TOWN WALL, HARTLEPOOL HEADLAND

A FORMAL RESPONSE BY TEESMOUTH BIRD CLUB TO A SCOPING REPORT

August 2009

RPT024

TOWN WALL AND HARBOUR, HARTLEPOOL HEADLAND SHOWING THE MAIN BIRD HABITATS

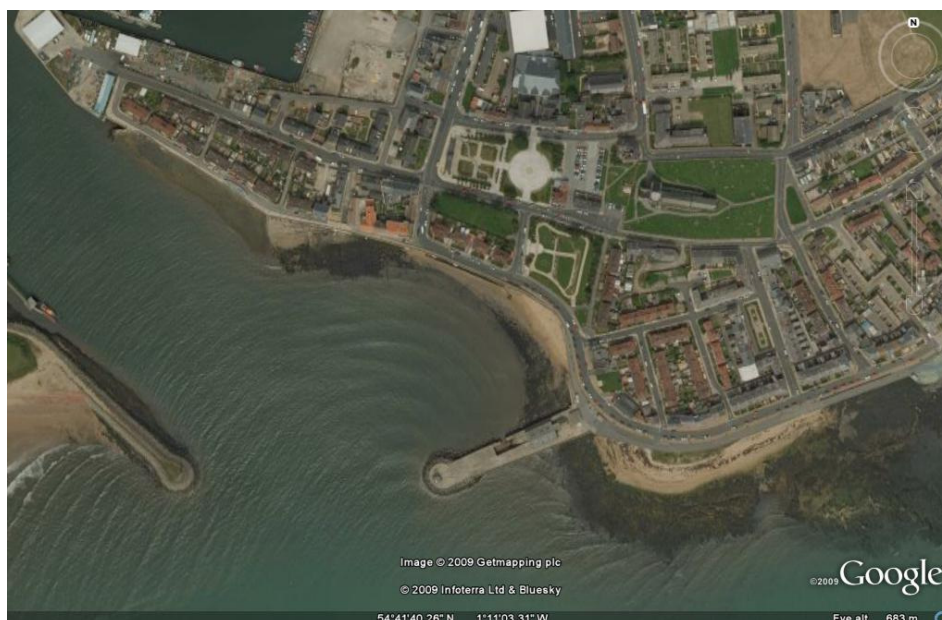
- 2.3 Our specific comments are as follows:
- (i) The area we are concerned with is Fish Sands, which fronts the gate through the Town Wall. As well as being a much-valued local beach, which is well used by local people, the sands also attract small numbers of wintering and migratory birds, such as Sanderling, Turnstone, Oystercatcher and Redshank. The construction of new groynes across Fish Sands would significantly reduce the value of this area for both birds and people.

- (ii) The rocky outcrops adjacent to the pier and below the northwestern (the old) section of the Town Wall are often used by birds. Eiders often rest here and the rocks are a favoured haunt of small numbers of wintering Purple Sandpipers, which feed among the seaweed-covered rocks. Other species often roost and feed, including Oystercatcher, Turnstone and Redshank, and terns occasionally rest on the existing groynes after fishing in the Harbour. Rock Pipit, a highly localised species in Cleveland, also occurs here.

- (iii) The open water of the harbour is an important area for birds, particularly in winter, and is regularly used by the following species: Eider, Red-breasted Merganser, Great Crested and Red-necked Grebes, Guillemot, Cormorant, and Red-throated, Black-throated and Great Northern Divers. The harbour provides shelter for storm-driven birds and is consequently well watched by birders. The key issue here will be potential disturbance during any construction works to repair or rebuild the wall.
